Office Action Summary	Application No. 10/807,932	Applicant(s) WEI, QINGQIAO	
	Examiner DENNIS M. WHITE	Art Unit 1797

DETAILED ACTION

FIG. 12

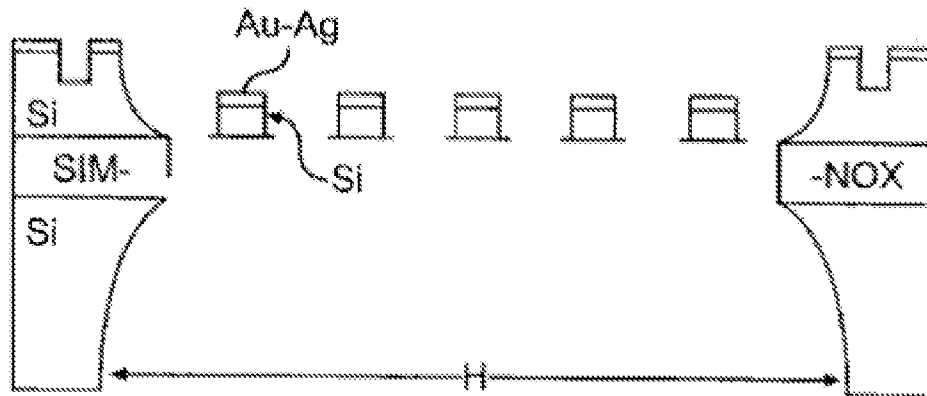
Kendall teaches the thin membranes may be heated and cooled in incredibly short times (Figure 12: "H"). It is not clear if Kendall teaches an integral heater.

integral thermal insulation SIM-NOX disposed to maintain the field-effect transistor at the elevated temperature.

Regarding claim 2, Kendall/Briand teach the functionalized semiconductor nanowire comprises silicon (Figure 12)

Regarding claim 14-15, Kendall/Briand teaches a substrate made of silicon on an insulator comprising silicon oxide that holds the MOSFET ("further comprising a substrate for supporting the field-effect transistor" "the substrate are formed from a layer of silicon on an insulator (SOI)" "wherein the integral thermal insulation is disposed on the substrate") (col. 11 lines 10-34, Figure 12).

Regarding claim 21, Kendall/Briand teaches wherein a portion of the substrate is removed to form an opening under the field-effect transistor (FET), the opening being at least partially aligned with the field-effect transistor (Figure 12)

Regarding claims 22-23, Kendall/Briand teaches the MOSFET ("field-effect transistor") comprises a SIMNOX layer (broadly interpreted reads on "substrate" "includes a gate electrically insulated from the substrate") (Figure 12: Si) which is fully capable of serving as a gate for the field-effect transistor.

Regarding claim 24, Kendall/Briand teach the gold-silver layer ("conductive catalyst") on silicon ("functionalized semiconductor nano-wire") is insulated from the substrate by SIMNOX layer which is fully capable of providing a gate for the field-effect transistor (Fig. 12).
